1. Traffic Engineering Response to Council's RFI DA/1080/2020, Liverpool Civic Place

1. DA-1080/2020 - Phase B/C Car Parking Provisions

St Marys Cathedral car park

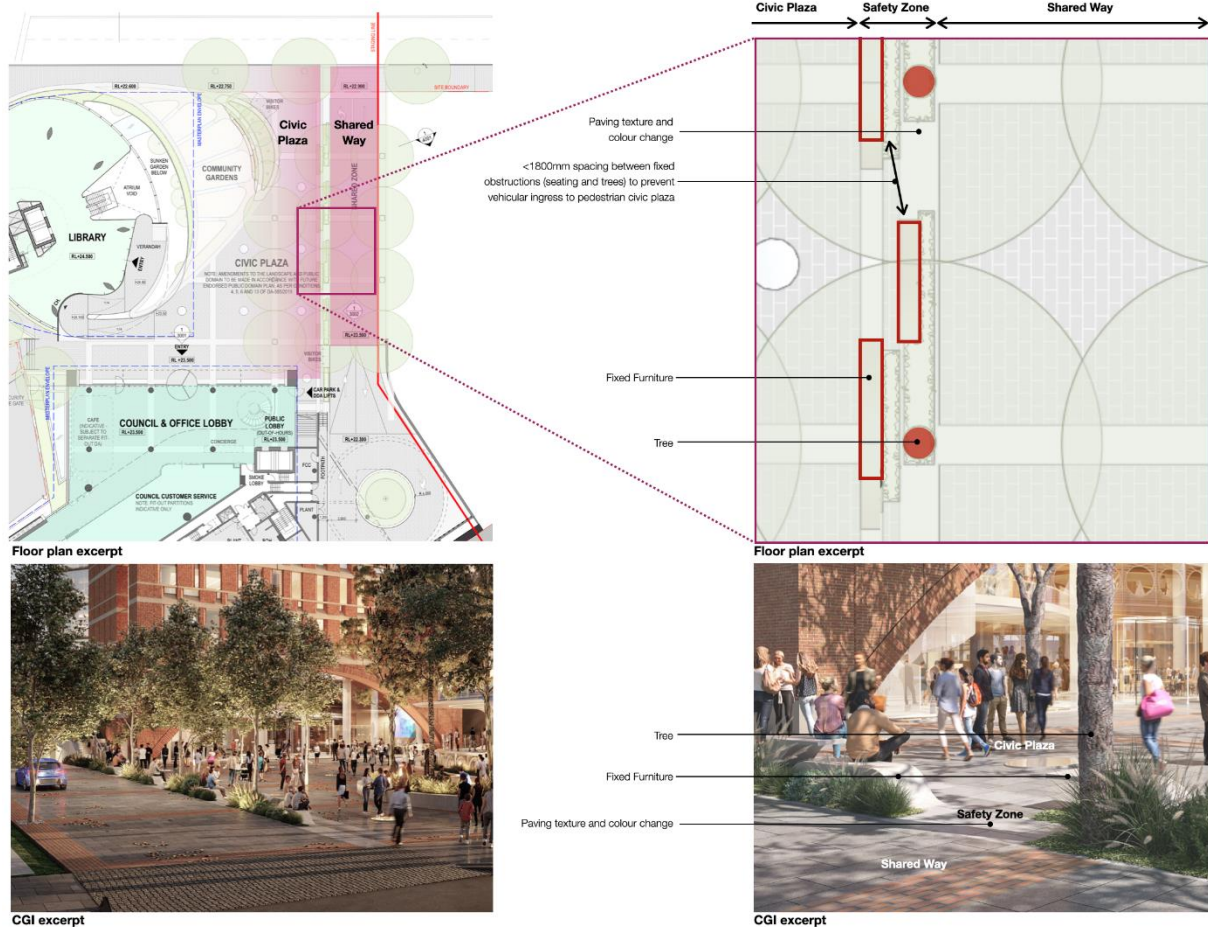
1E(i) - The proposal suggests a shared zone on Scott Street. Further details are required as all shared zones must comply with TDT 2016/001.

The shared zone proposed has been adopted as a means of prioritising pedestrian movement across the plaza in line with the objectives of the Technical Direction. Other examples that have been referenced in the design of the shared zone include, St Marys Cathedral car park, The Crescent, Mosman, St Margarets in Surry Hills, Mount Street in North Sydney and Circular Quay (east).

The shared zone will be supported by the required signage, and safety provisions such as the high contrast edge-lines designed into the plaza landscaping design, the trees and seating to prevent errant vehicles accessing the plaza etc. This will be subject to detailed design during the CC stage of the project to ensure compliance with TDT 2016/001.

Public domain plan includes physical items that prevent a vehicle travelling from the shared zone to the plaza (maximum gap of 1800mm to prevent vehicles pass between the physical objects).
